Product Change Notification

PCN #: 4B-2019

DATE: 23rd April 2019

Laird Part Number	Description
451-00001	Module, BL654 Series, Integrated Antenna
451-00002	Module, BL654 Series, External Antenna
451-00003	Kit, BL654 Series, USB Adapter
455-00001	Development Kit, BL654 Series, Integrated Antenna
455-00002	Development Kit, BL654 Series, External Antenna

Figure 1: Module label

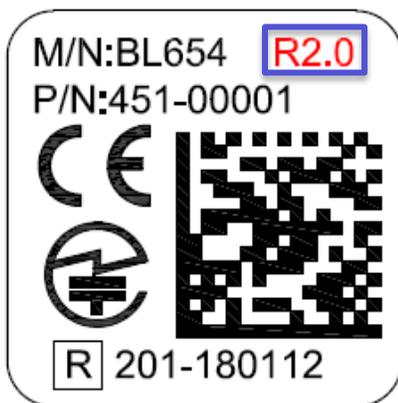
The change can be identified by reviewing the *Hardware Revision Code* number that is present on the individual module, reel label and carton label. The images below identify where this 'Hardware Revision Code is located on each of those labels.

A Hardware Revision Code that shows as R2.0 indicates that the nRF52840-QFAA-D00 silicon is utilised.

A Hardware Revision Code that shows as R1.0 indicates that the nRF52840-QFAA-C00 silicon was utilised.
